Amendments to the Drawings

REMARKS

Annotated Drawing Showing Changes
 Sheet 1 of 1
 Appln. No. 10/762,633

FIG. 7 (PRIOR ART)

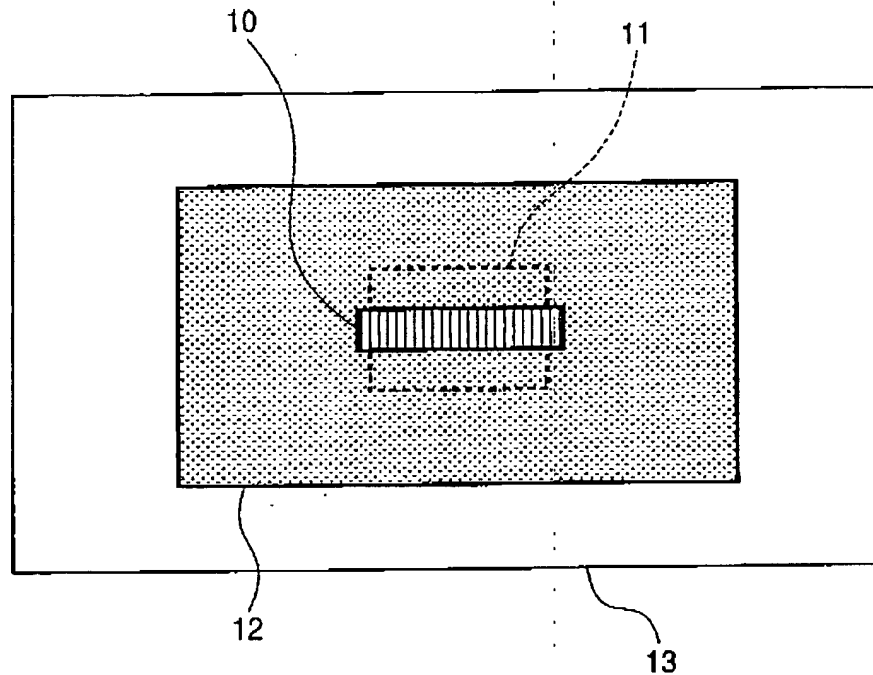
The Examiner has objected to applicant's FIG. 7 and required FIG. 7 to be designated by a legend such as -Prior Art - because only that which is old is illustrated. Applicant has amended applicant's FIG. 7, as shown in the Replacement Drawing and the Annotated Drawing Showing Changes, to include a legend "PRIOR ART," as suggested by the Examiner. The Examiner's objection is therefore obviated.

The attached Replacement Sheet of drawings includes changes to FIG. 7. This sheet, which includes FIGS. 6 and 7, replaces the original sheet including FIGS. 6 and 7. In FIG. 7, a legend "PRIOR ART" has been added.
